Meeting Minutes: Plumbing Board

Date: Jan. 21, 2025
Time: 9:30 a.m.
Minutes by: Lyndy Logan
Location: Minnesota Room, DLI, 443 Lafayette Rd. No., St. Paul, MN 55155

D. **Variance Petition, Oak-Land Middle School – Larson Engineering (Attachments B & C)**

To: Minnesota State Plumbing Board Date: December 10, 2024
From: Larson Engineering, Inc. Project No: 12246044
Project: Oak-Land Middle School Additions & Renovations
Re: Variance Regarding 2020 Minnesota Plumbing Code Section 310.5

PROPOSED CONDITIONS IF VARAINCE IS DENIED

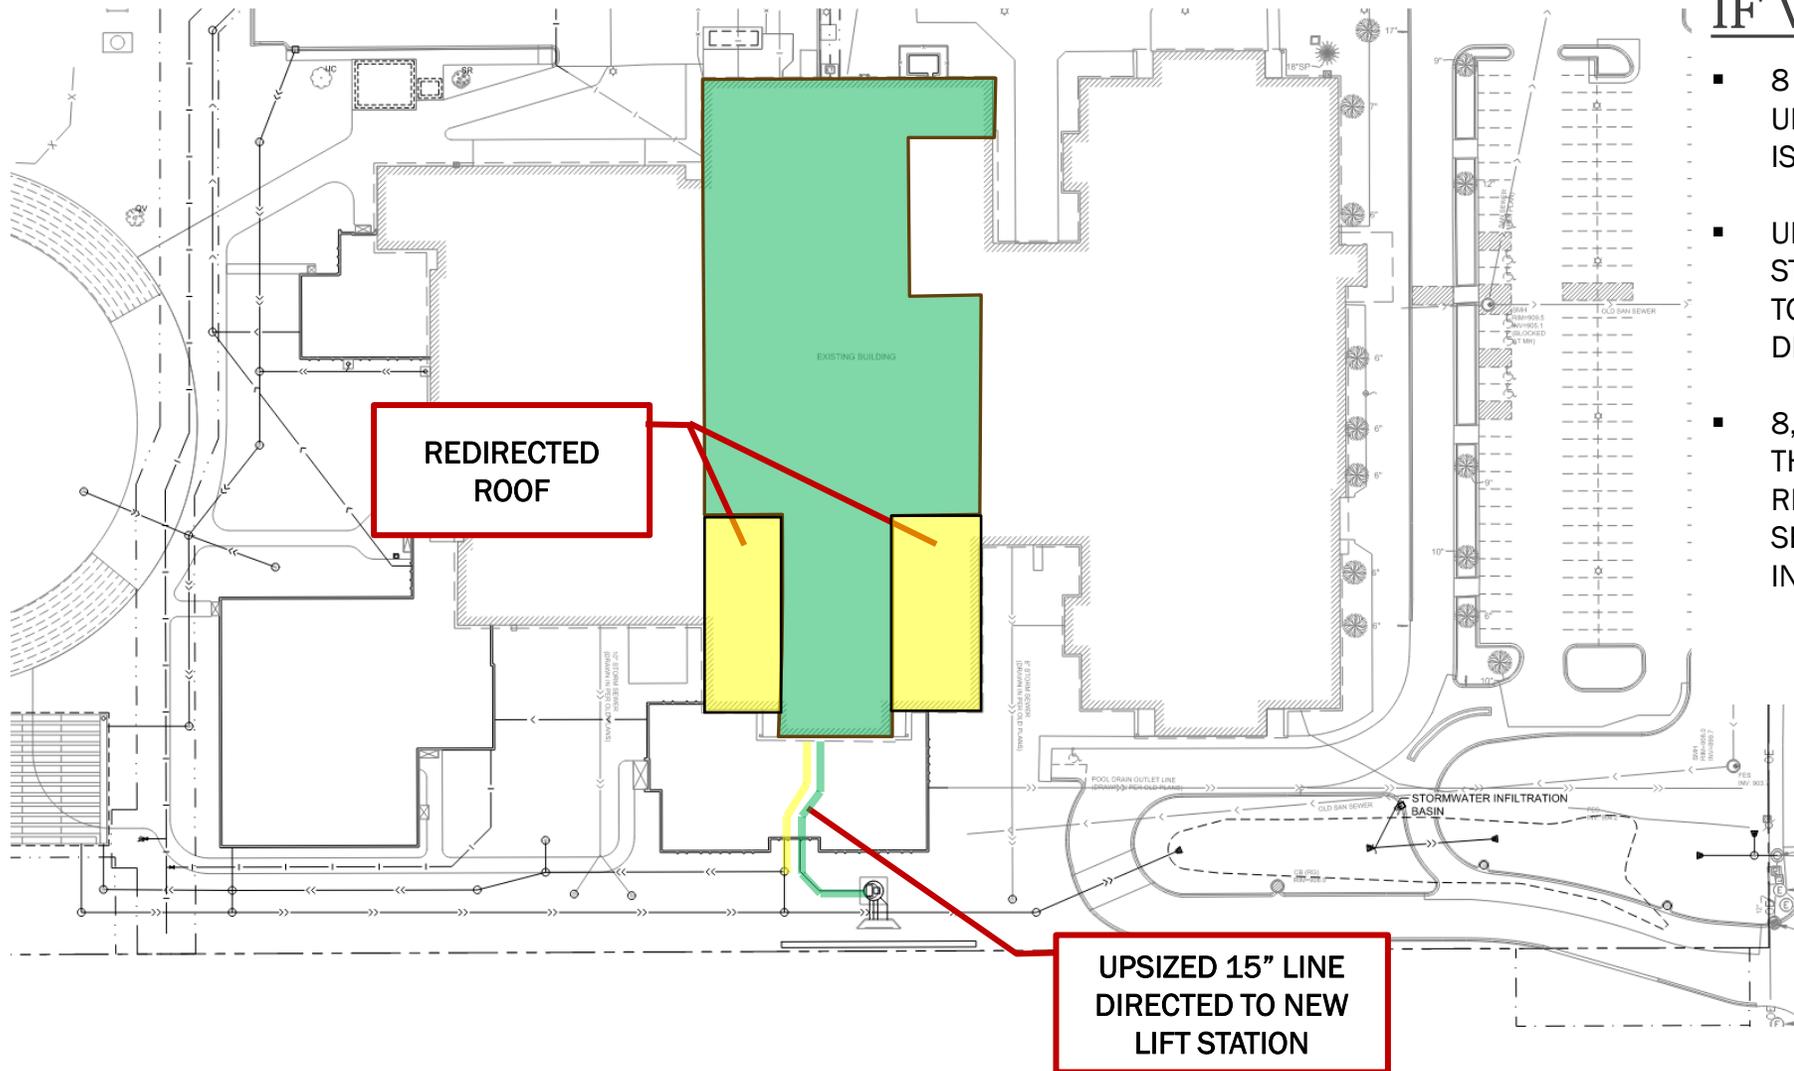
- 8 INCH VCP IS REVISED TO A 15 INCH PVC UNDER NEW ADDITION, DOWN STREAM PIPING IS ADJUSTED ACCORDNGLY
- UPSIZED PIPE CONNECTS INTO A NEW LIFT STATION STRUCTURE DESIGNED TO BE ABLE TO PUMP 2,900 GALLONS PER MINUTE AND DISCHARGES ON GRADE.
- 8,400 SF OF EXISTING ROOF THAT GOES TO THE EXISTING 8 INCH LINE WILL BE REDIRECTED TO A NEW ROOF LEADER SERVICED BY A NEW UNDERGROUND INFILTRATION SYSTEM.

- Chair Becker confirmed Lemke's summary and recommended denying the variance since the proposed alternative meets the code. He noted that past interpretations likely led to surcharges but emphasized the need to comply with the current code moving forward. Acknowledging the significant cost of the lift station, he stated that while avoiding mechanical devices is preferable, the new setup must adhere to current code requirements. The key issue isn't the discharge end, so he recommended not approving the variance request.

A motion was made by Becker, seconded by Erickson, to deny the variance petition request for Oak-Land Middle School. As presented, there is an alternative approach designed using a lift station that would allow the piping to not be surcharged, complying with the code; therefore, even with the increased cost, this is not reason enough to allow the variance. The majority roll call vote ruled with 10 in favor, one against (Wahlen), and one abstention (Parizek); the motion passed.

SHEET TITLE: SURCHARGE EXHIBIT
 SHEET NUMBER: C153

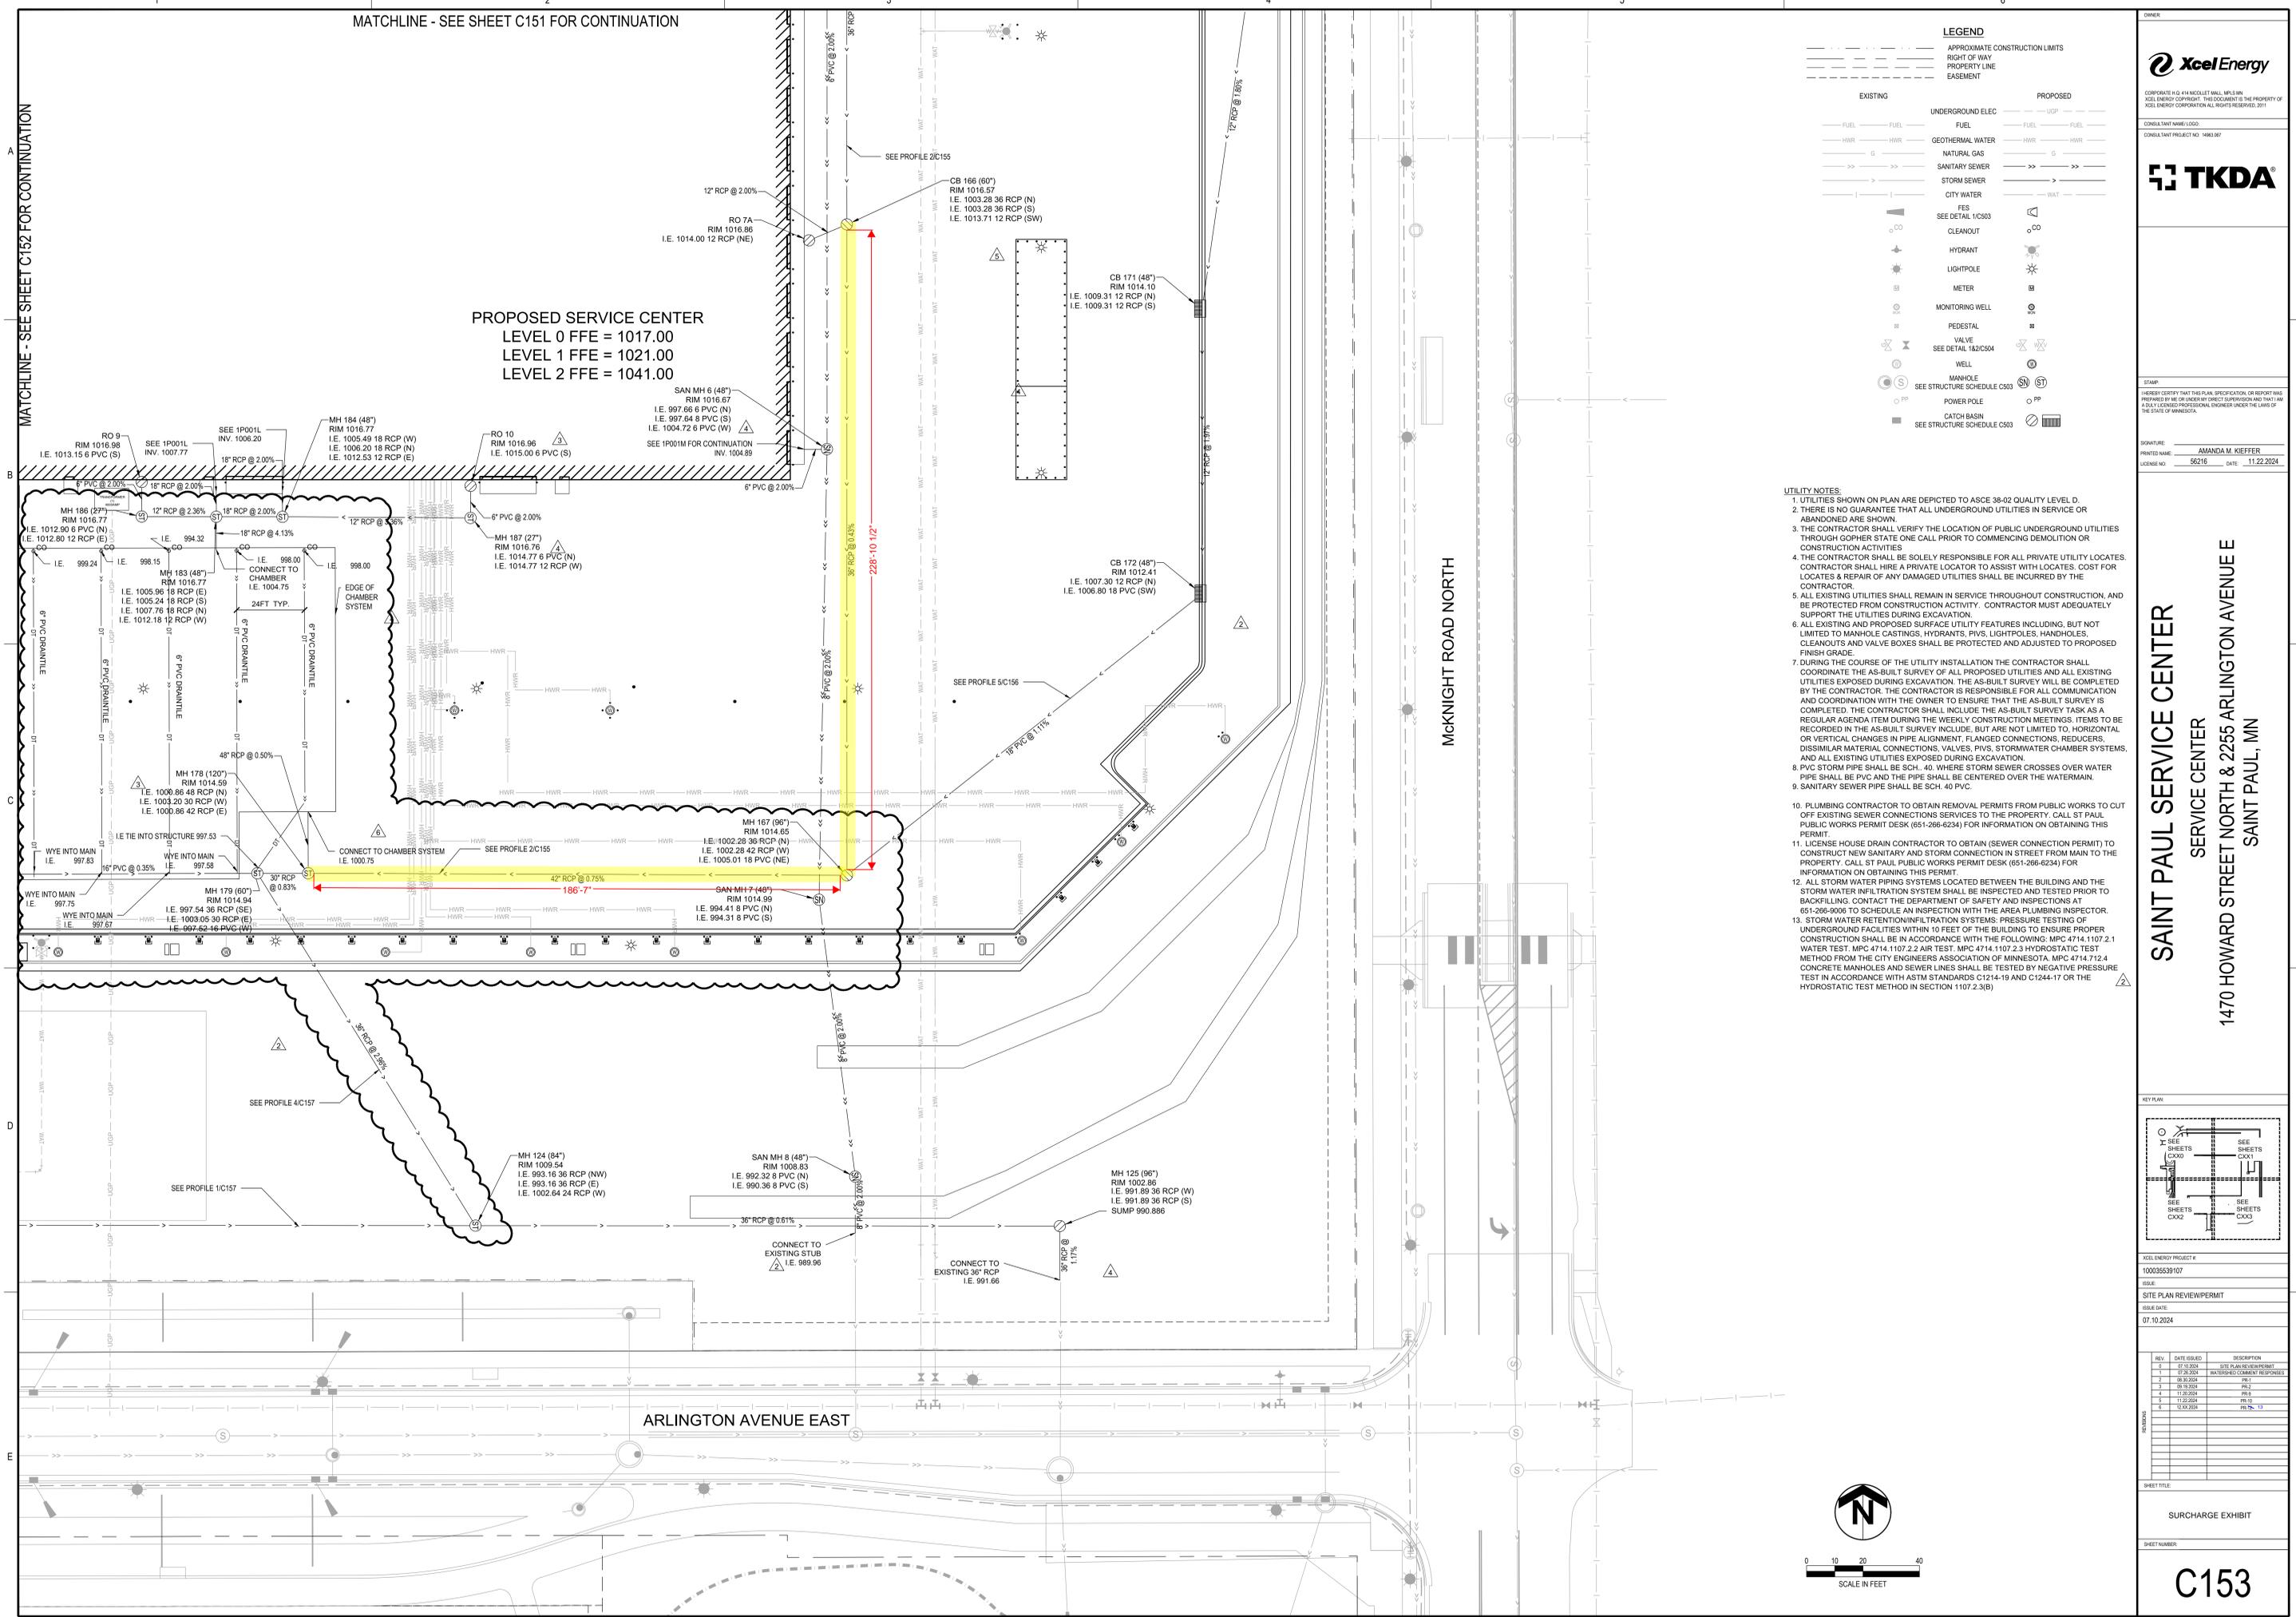
- 2020 Minnesota Plumbing Code, Section 310.5, Obstruction of Flow.
- Key Points
 - The original design of the storm sewer pipe and stormwater filtration chamber system for this project met the code for the Water Quality Event (all 3 definitions further described in these slides).
 - During construction of the stormwater chambers the contractor encountered an unforeseen and unexpected condition. The groundwater level is at an elevation higher than expected. The ground water elevation is 3.5 feet above the bottom of the chamber system.
 - Therefore, the chamber system needs to be revised by raising it above the groundwater level, a vertical distance of 3.75 feet.
 - This revision will result in temporary surcharging pipe upstream of the chamber system.

- The surcharged pipe is temporary. The stormwater filtration chamber system will draw down in 48 hours, through filtration, and drain the water in the surcharged pipe. The surcharging is limited to pipes directly upstream of the chamber system.
- No water will surcharge any pipes at the proposed building in any rain event up to and including the 100-year event.
- The surcharging is a temporary condition. However, the request for a variance is permanent.
- Alternatives for construction were considered with the Geotechnical Engineer to keep the system at its current elevation with the ground water, but it was determined to be infeasible due to:
 - The amount and flow of the ground water.
 - The clay soils and limited pumping options.
 - Soil Instability.
 - Constructability and durability of the system liner within groundwater.
 - Buoyancy concerns during construction.

A motion was made by Wahlen, seconded by Wood, to approve the variance petition for Xcel Energy St. Paul Service Center. The majority roll call vote ruled with 10 in favor and two abstentions (Abrahamson and Pylkas); the motion passed.
